Service Bulletin

Elevator Hinge Upgrade

GA8 serial numbers GA8-04-054 through GA8-07-114, and any GA8 aircraft prior to S/N GA8-04-054 retrofitted with machined hinge brackets by Engineering Release.

Figure 1

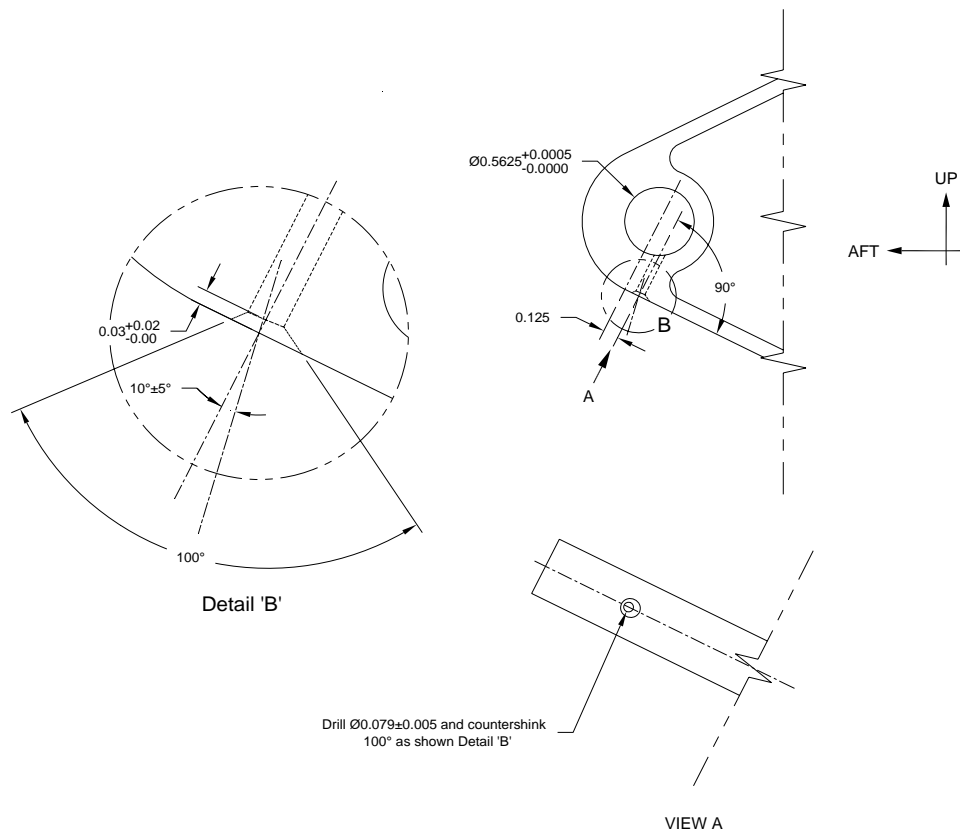
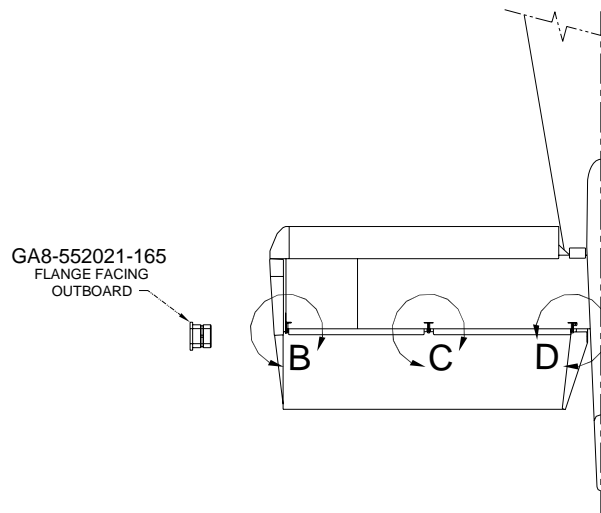
Issue 3: Lubrication hole moved 0.125". See Figure 1.

- 1.3. Drill lubrication holes of diameter 0.079" ± 0.005" [2.00 mm ± 0.13 mm] in the elevator hinge brackets in accordance with figure 1, and countersink at 100° as shown.

Figure 2

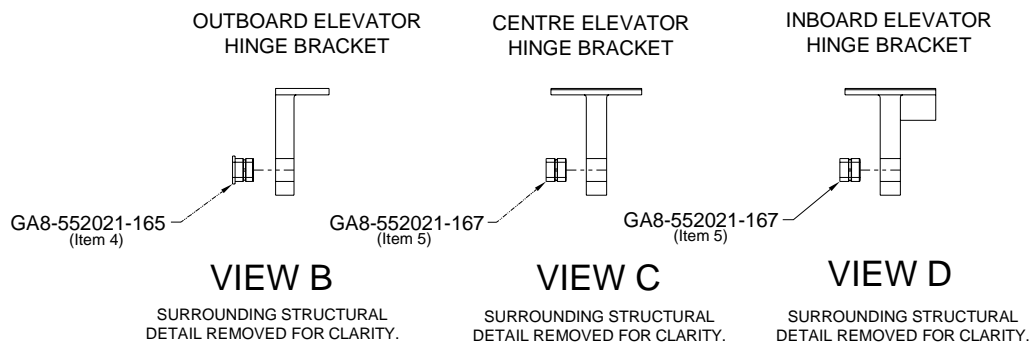
- 1.4. Install the outer bushes (items 4 and 5) with an interference fit in the respective inboard, centre and outboard hinge brackets for each elevator hinge using Loctite 603 (or equivalent), with the flange of each outboard bush located on the outboard face of the respective hinge bracket. The inboard and centre outer bushes are identical. See Figure. 2

ELEVATOR HINGE OUTER BUSH INSTALLATION
